SUBJECT: Savannah River Site's Responses to the Regulatory Comments on the R-Area Groundwater (NBN) Biennial Effectiveness Monitoring Report in Support of R Area Operable Unit (U) January 2019 through December 2020 (SRNS-RP-2021-03617, Revision 0, June 2021) SEMS Number: 95

SRS Responses to EPA comments on the R-Area Groundwater (NBN) Biennial Effectiveness Monitoring Report in Support of R Area Operable Unit (U) January 2019 through December 2020 (SRNS-RP-2021-03617, Revision 0, June 2021) SEMS Number: 95

TECHNICAL REVIEW COMMENTS

Figure E-1. R-Area TZ Well Water Elevations 2020

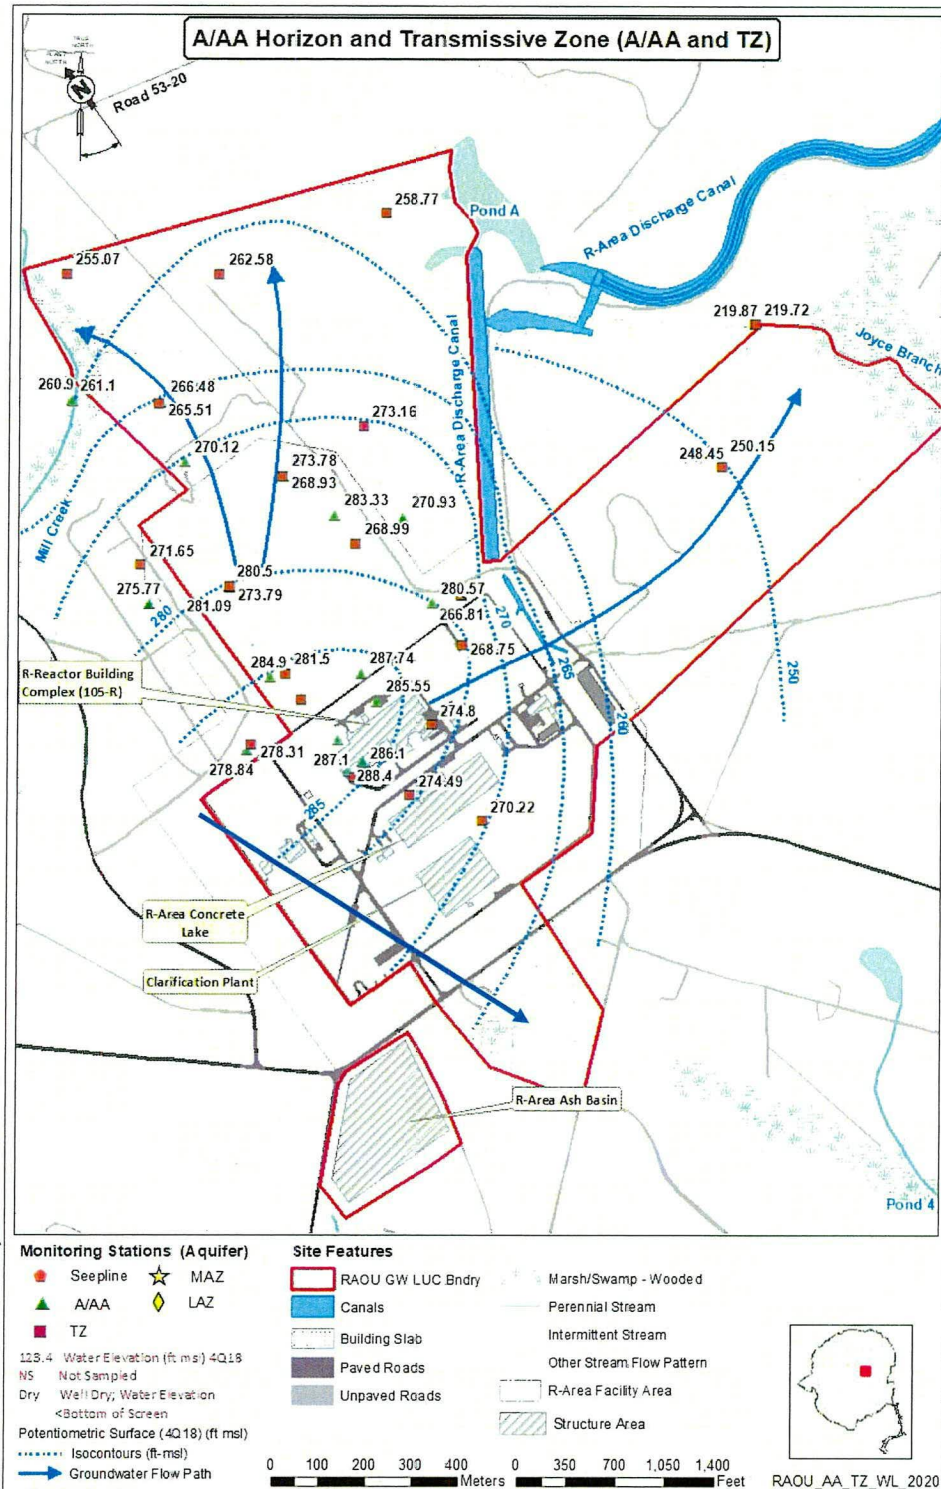
2. Section 3.3, Groundwater Flow Directions, Page 5 of 40: The text states that the groundwater flow in the Transmissive Zone (TZ) is radial. The text also states that the groundwater flows south towards Pond 4; however, Figure E-3 (R-Area LAZ Well Water Elevations 2020) is missing an arrow indicating flow towards Pond 4 to the south. Revise the EMR to add a flow direction arrow on Figure E-3, Page E-3 of E-8.

Response: Agree with Clarification.

Figure E-1 in the next EMR will include a groundwater flow path arrow towards Pond 4, as indicated in the attached revised Figure E-1. In the LAZ, groundwater flow is not as radial as in the TZ, so a groundwater flow path is not warranted in Figure E-3 for the LAZ.

R-Reactor Water Table History

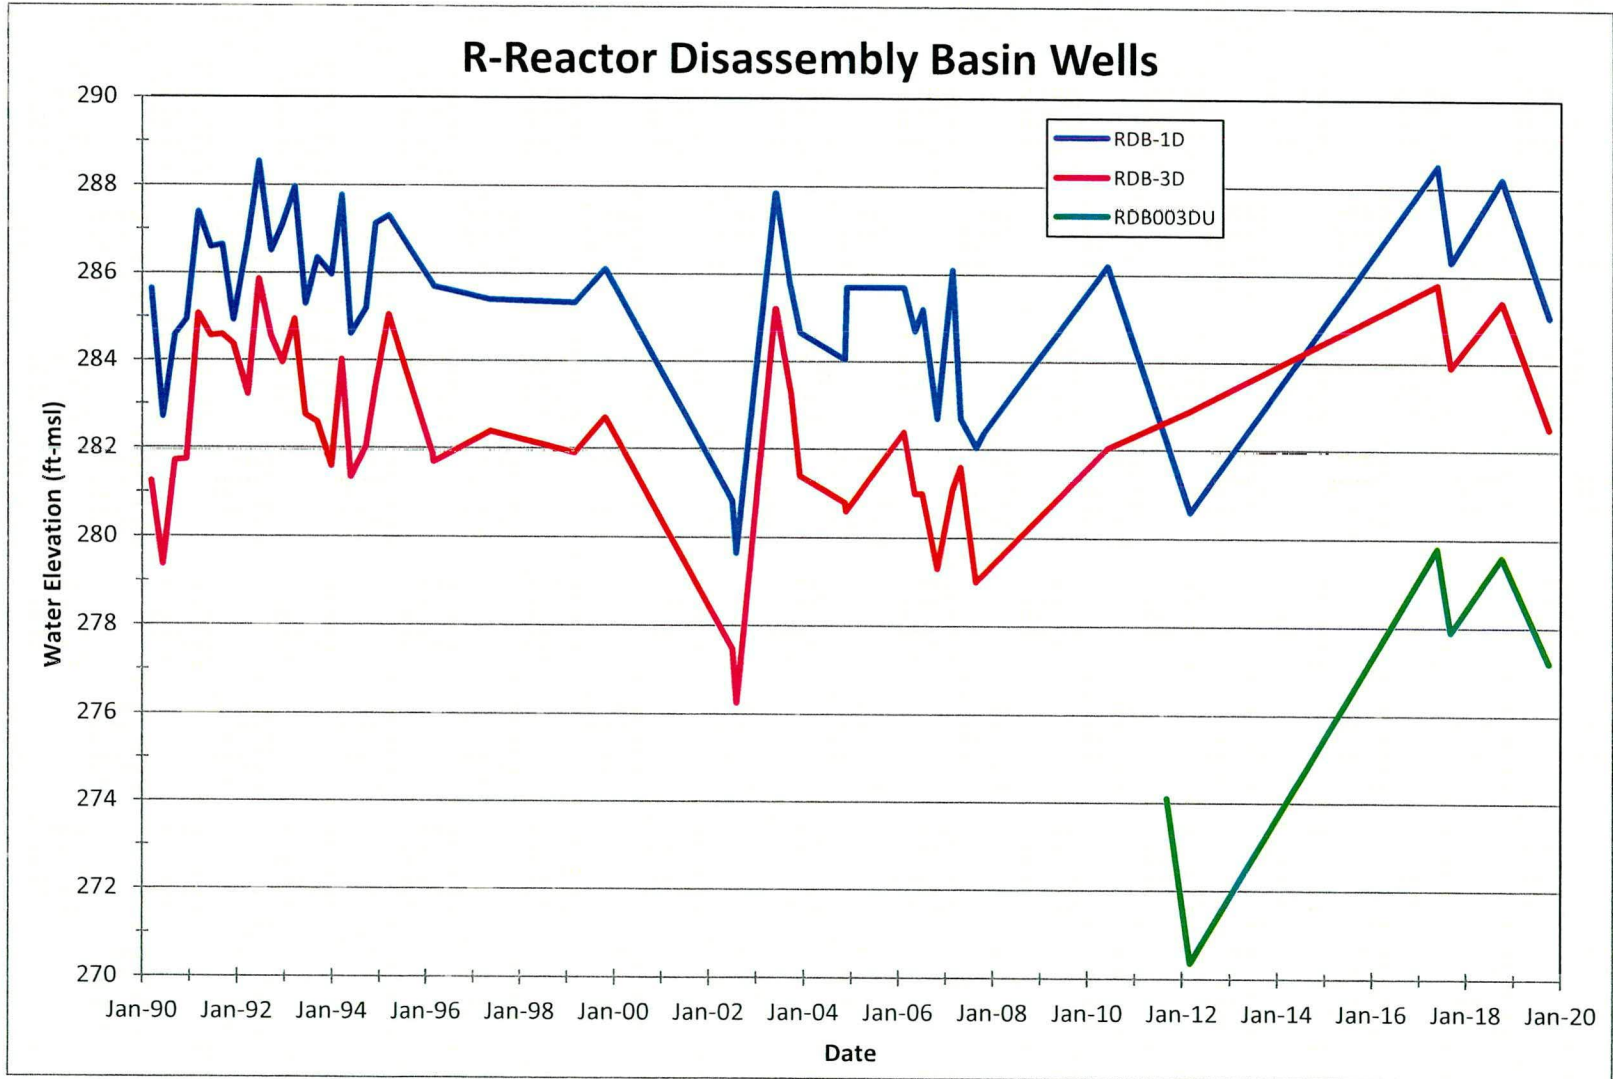
6. **Section 5.2, ISD Conclusions, Page 14 of 40:** The text states the 2017 and 2020 increase in tritium and carbon-14 at well RDB 3D may be due to mobilization of a small shallow legacy spill near the disassembly basin, related to the recent high-water table levels. The EMR also notes that greater than average rainfall was measured at the Savannah River Site during 2020. As such, it is unclear if the annual monitoring event is scheduled during the rainy season when high water table conditions exist to ensure representative groundwater samples are collected to monitor potential source mobilization near the disassembly basin. *Revise the EMR to state whether the in-situ decommissioning (ISD) monitoring is being conducted during the rainy season.*

Response: Clarification.

The SRNL Meteorological Monitoring Program at the Savannah River Site (SRNL-TR-2020-00197) indicates rainfall is fairly well distributed throughout the year, though slightly lower in the fall. The long-term averages indicate this rainfall

distribution, but the maximum monthly rainfall measurements indicate the high degree of variability from month to month. The high degree of variability for each month from year to year makes it difficult to time groundwater sampling with maximum rainfall events/periods. Table 2-2 (attached) from the SRNL report shows the average, maximum, and minimum rainfall for SRS through 2019. This variability is also indicated in the water table fluctuations in the RDB wells near the R-Reactor (figure attached). No change in monitoring frequency is planned for the RAOU groundwater.
